**LEVEL 10
477 COLLINS STREET
MELBOURNE VIC 3000**

NO. 37 GRAHAM ROAD, HIGHETT DEVELOPMENT PLAN RESPONSE TO POST-CONSULTATION COUNCIL FEEDBACK

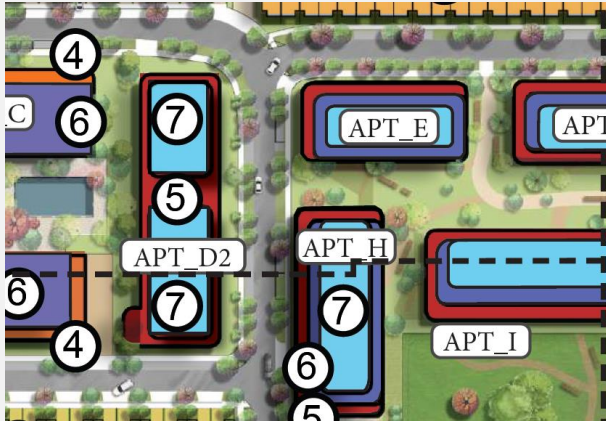
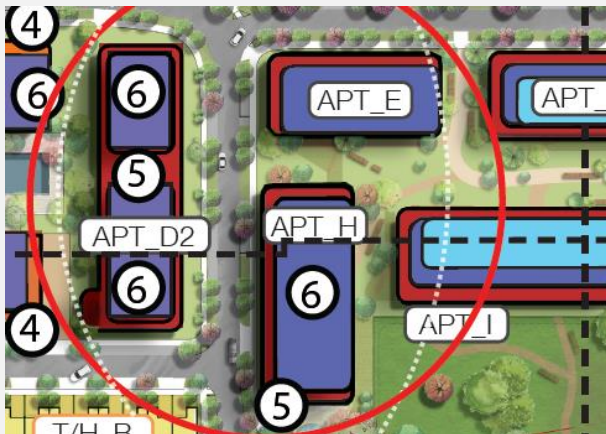
Issues raised in submissions	Sunkin response (<i>without prejudice</i>)	Ref. doc. Attached
<ul style="list-style-type: none"> Scale and density proposed, specifically the extent of seven storey building elements. 	<p>The DPO allows discretion in maximum building heights subject to balancing amenity outcomes. The highest building forms are directed to the northern part of the site. The DPO does not include a plan showing the precincts, and the team has identified higher development as being acceptable within around 500m of the Highett railway station.</p> <p>Higher development is located well away from low density residential interfaces. As an example, apartment building G is located 37m from the Middleton Road Residents boundary with 3m setbacks at level 6 and a further 3m setback at level 7.</p> <p>Apartment J is located 57m from the Graham Road resident's boundary with further 4m setbacks at level 6 and a further 3m setback at level 7.</p> <p>The two and three level built form zones along the site boundaries further reduce the effective visual impact of the apartment buildings which are set down in the site contours and distant to the site boundaries.</p> <p>As such the proposed design, within this unusually large, high-density capable development site, is relatively modest and complies with the intent of the planning controls for the site.</p> <p>However, in response to community feedback, it is proposed to reduce the height of buildings D2, E and H from the 7 storeys depicted in the DP, down to 6. This height reduction in the centre of the site will reinforce the height transition from the north to the conservation zone, stepping down from 7 storeys to 2 storeys, responding to the DPO2 objectives for height.</p>	<p>Masterplan – Proposed heights document</p>

Building A

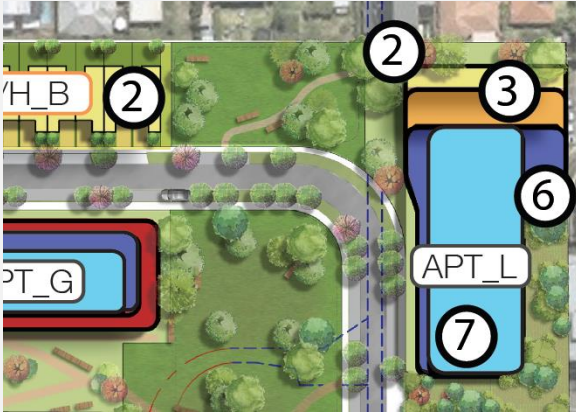
<ul style="list-style-type: none"> Building interfaces with adjoining properties, particularly buildings A and L interface to Middleton Street properties 	<p>The advertised Development Plan proposal for Building A and L already easily comply with ResCode setback requirements.</p> <p>However, in response to community feedback, it is proposed to increase the upper-level setbacks of buildings A and L from the western site boundary. This results in all buildings to be constructed within 18m of the shared site boundary with Middleton Road (rear fences) to be no more than 3 storeys in height. Again, the result is much better than the ResCode setback requirements.</p>	<p>Masterplan – Proposed heights document</p>

The fourth and fifth storeys of Building A are now proposed to be setback a minimum of 20 metres and 23 metres respectively from the boundary to Middleton Street properties.
